Victorian Society Testimony for February 25, 2025: 186 8th Avenue (LPC-25-04579); 28 7th Avenue (LPC-25-04975); 186 Underhill Avenue (LPC-25-04543); 21-20 45th Avenue (LPC-25-05359); 112-114 Chambers Street (LPC-24-05964); 74 MacDougal Street (LPC-25-04391); 640 Park Avenue, aka 65-75 East 66th Street (LPC-25-05481); 2878 Broadway (LPC-25-05250)

LPC-25-04579 -- 186 8th Avenue - Park Slope Historic District, Brooklyn

76 MacDougal Street

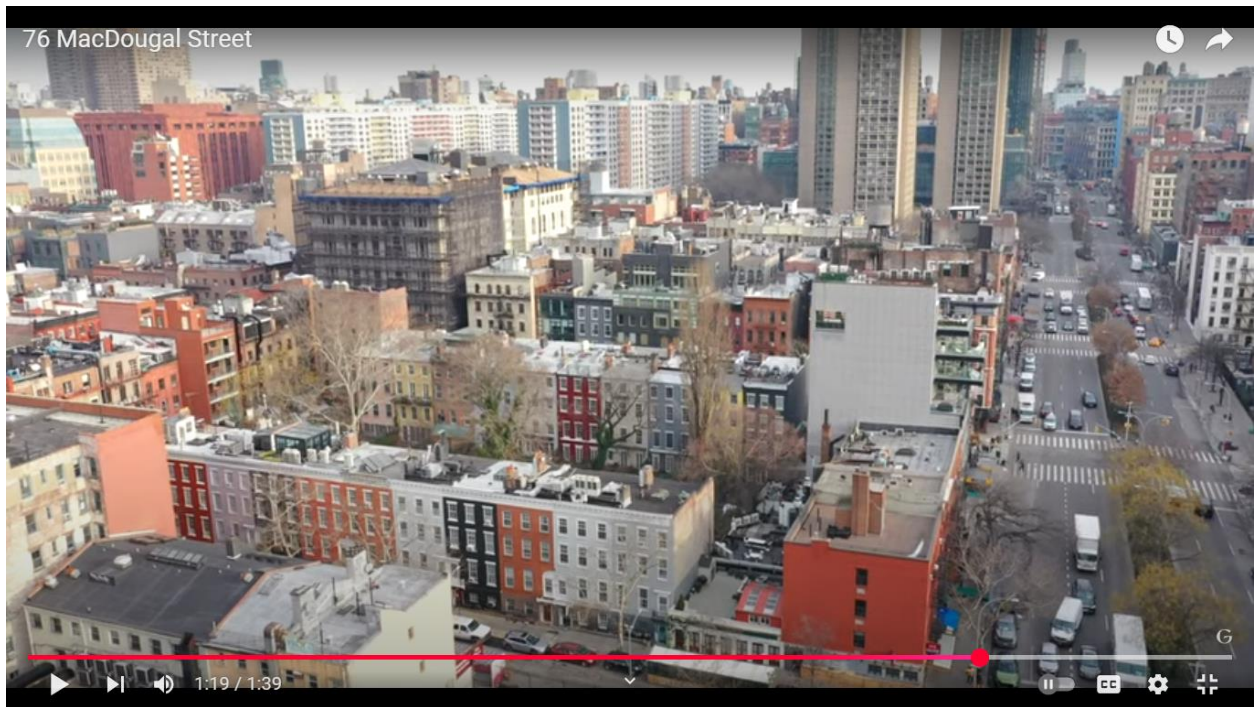
The proposed change to the rear façade is perhaps even more problematic. MacDougal-Sullivan Gardens is an important district in the history of housing in NYC. The 1920 alterations to then deteriorated Greek Revival houses created uniform rear facades facing a common garden. The architectural significance of these rear facades is much greater than for typical row house districts. The presentation materials give little indication of the uniformity of appearance of these rear facades. The three pictures in our written testimony show that most, and likely all, of the rear facades at the parlor floor retain their historic configuration of three multi-light, double-hung windows in punched masonry openings. Some of the ground floor facades have been changed, but the overall effect of the facades facing the common garden is of a consistent treatment throughout.

The proposed alteration of the rear parlor floor windows is typical of the kind of change the Commission regularly approves in other districts. In this district, however, such a change is not appropriate.

See three pictures below.

No action; reduce visibility of rooftop addition.
